January 12, 2021
ES-6947.04

**Subject: Response to Comments
Proposed Marbella Residence
7311 West Mercer Way
Mercer Island, Washington**

Reference: Earth Solutions NW, LLC
Geotechnical Engineering Study
Project No. ES-6947.01, dated November 14, 2019

Earth Solutions NW_{LLC} Geotechnical Engineering, Construction Observation/Testing and Environmental Services		Earth Solutions NW_{LLC}	
Foundations Adjacent To Slopes Marbella Residence Mercer Island, Washington			
Drwn. MRS	Date 01/11/2021	Proj. No.	6947.04
Checked CGH	Date Jan. 2021	Plate	1

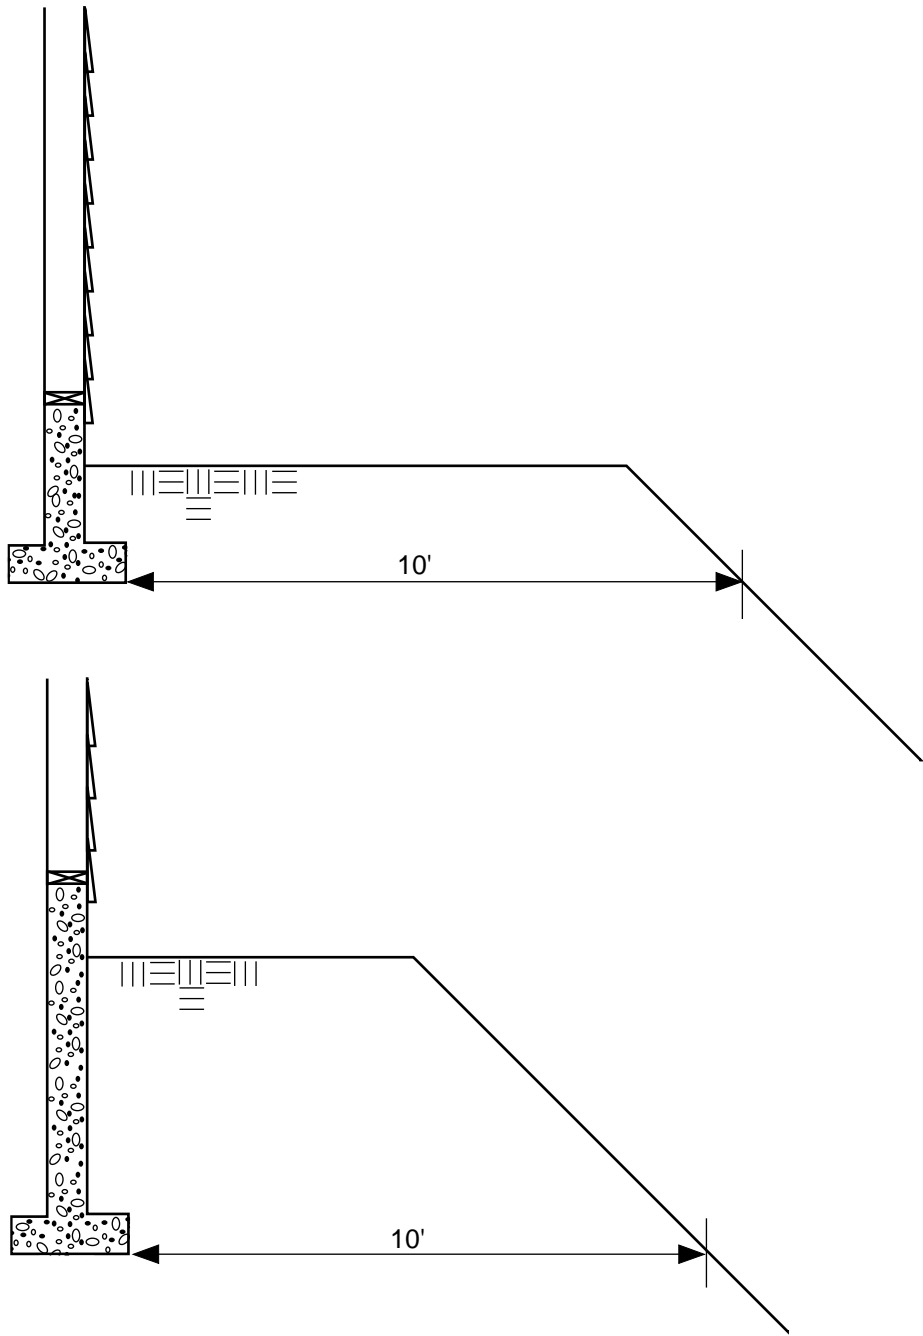
City Comment – Geotechnical engineer to provide recommendations for footings located on or adjacent to steep slope. Recommendations to include minimum embedment of footings with detail showing footing and slope for clarification and allowable soil bearing pressure given the presence of the steep slope.

ESNW Response – In our opinion, foundations near sloping areas should maintain a 10-foot setback from the slope face. This can be achieved by either constructing foundations 10 feet from the top of slope or advancing the foundation sufficiently to maintain a 10-foot horizontal setback between the foundation and slope face. Please see the attached Plate 1 (Foundations Adjacent To Slopes) for a depiction of these recommendations. Provided that competent native soils are encountered at subgrade elevations, the previously recommended allowable soil bearing capacity of 2,500 psf is considered suitable for design. Based on our test pit exploration, we anticipate glacial till to be prevalent throughout the area; as such, we do not anticipate adverse impacts to the slope during foundation preparation activities. ESNW should be retained at the time of construction and foundation preparation to observe field conditions and provide additional recommendations, where necessary.
